STAFF REPORT 5-8-2019 MEETING

APPLICATION NUMBER: 19-6188

ADDRESS: 3977 SECOND

HISTORIC DISTRICT: WILLIS SELDEN/CAMPBELL SYMINGTON

Sanborn Fire Insurance Map, 1897.
Note that rear porch is not present

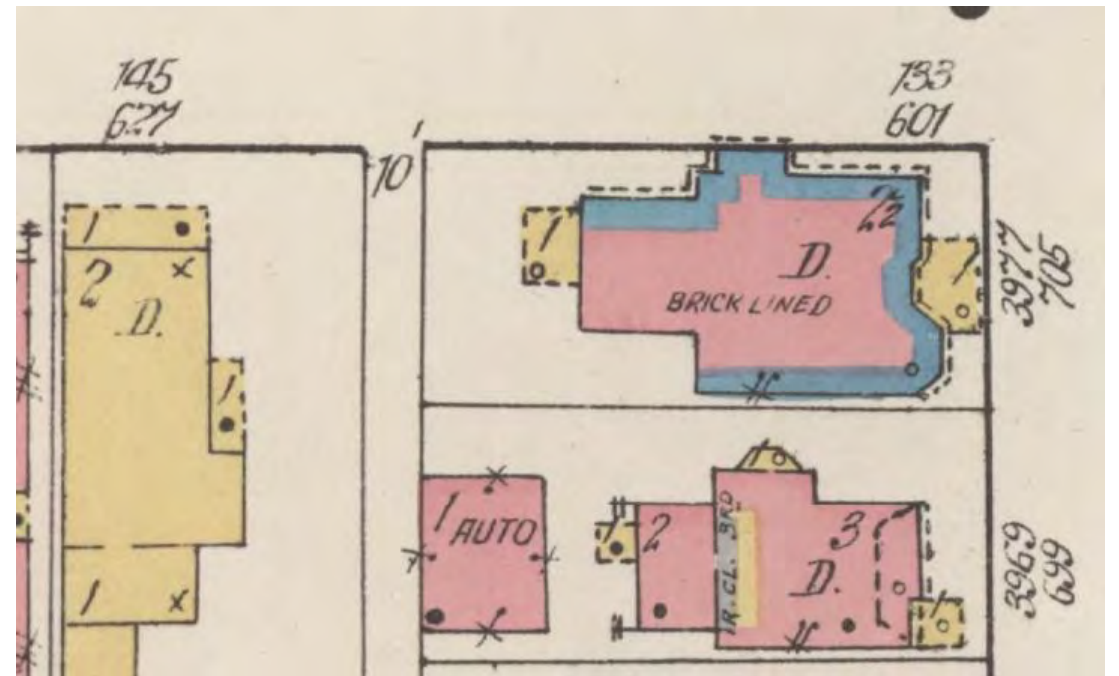
Please see the below-attached Sanborn Fire Insurance Maps which date from 1897, 1921, and 1950. A review of these maps indicate that the rear porch proposed for removal does not date from the building's original construction. Rather, a rear porch appears sometime between 1897 and 1921. According to the Sanborn maps, the

original historic-age rear porch was roofed in slate or metal, whereas other nearby rear porches in less visible locations show composition (asphalt) roofs. Such treatment may have been due to its visibility from the public way, as the rear of the house here was also dressed in stone.

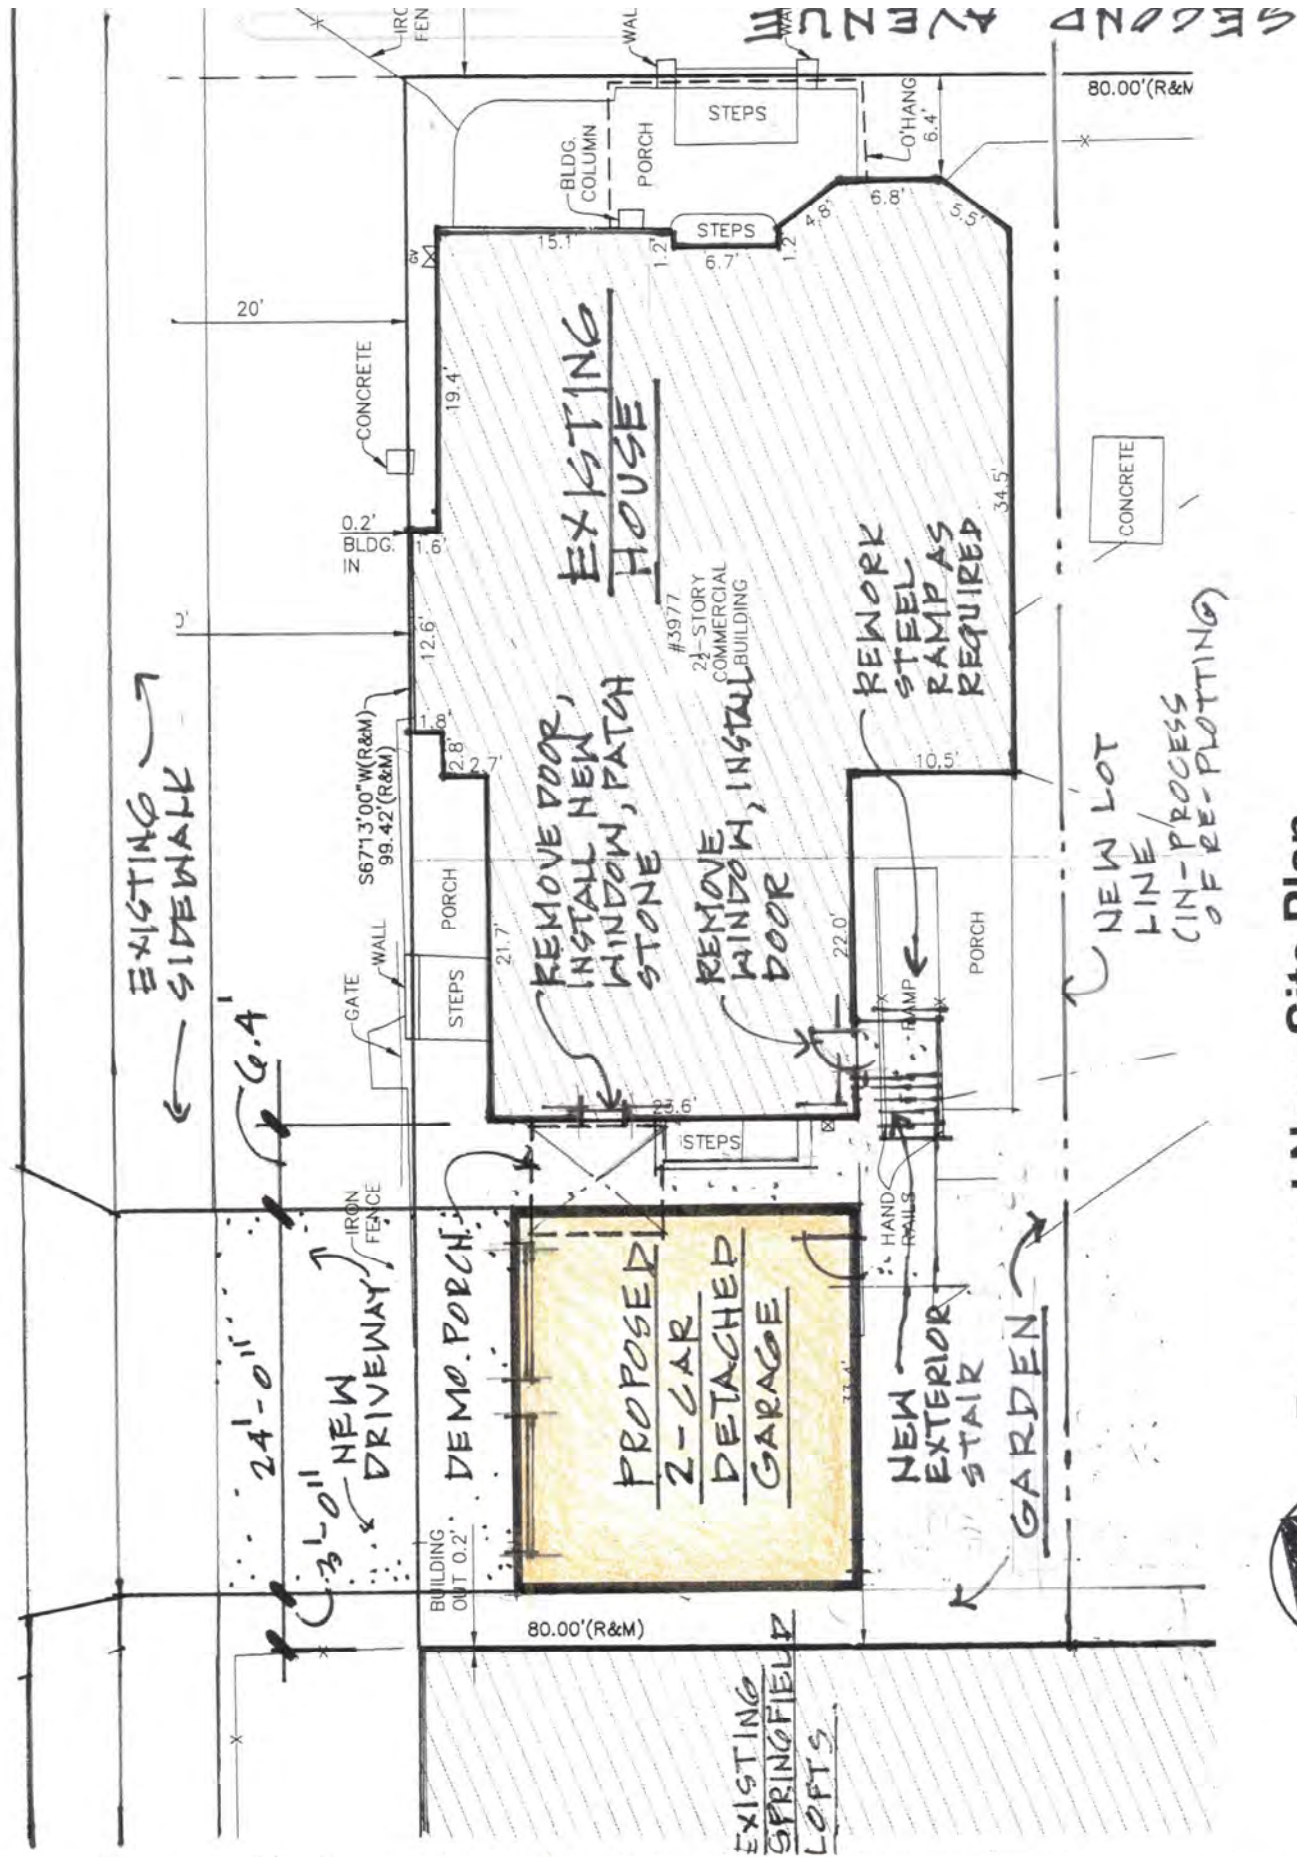
Please see the newly revised West Elevation drawing that now shows the proposed new window to have two equal glass sections to better match the adjacent existing kitchen windows on the North elevation. Disregard the original proposed new window that featured a smaller transom section on top with a large casement unit below. This new window will match the existing house's window frame color and profile to appear original.
